DUKE POWER COMPANY

June 14, 1988

Subject: Catawba Nuclear Station, Units 1 and 2
Docket Nos. 50-413 and 50-414
NRC Request for Additional Information on
Performance Testing of Relief and Safety Valves

FIGURE 1 SHT. 1

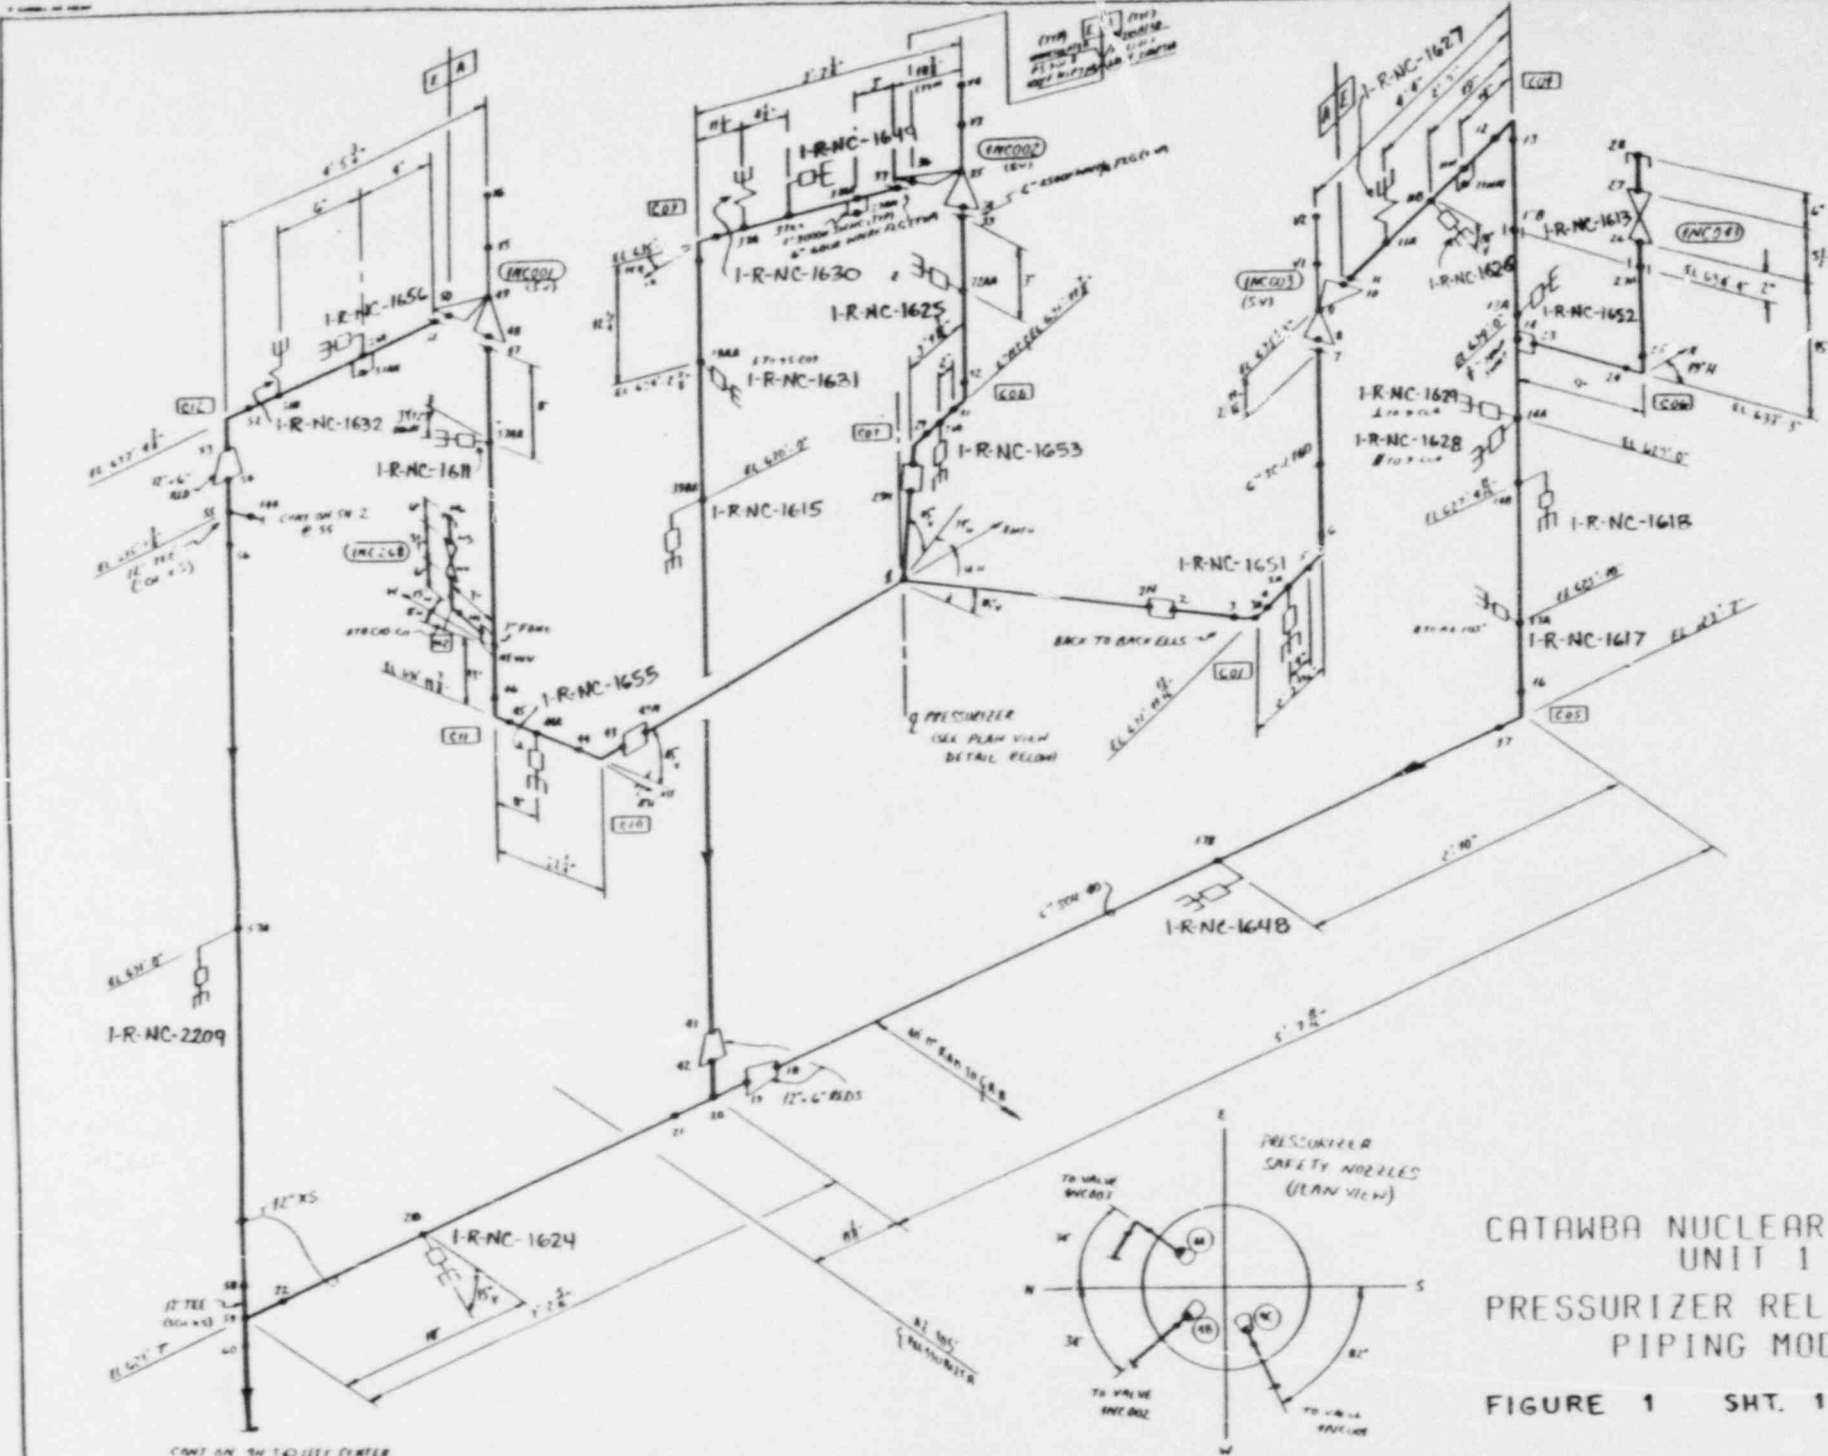
Provide a sketch of the structural model showing lumped mass locations, pipe sizes, support locations and application points of fluid forces.

Masses are lumped at points of discontinuity and at a maximum spacing of "S" in straight pipe as explained in question 12(b). Sketches showing discontinuity points, pipe sizes, and support locations are found on the following drawings:

Figure 1 - Unit 1 (3 sheets)
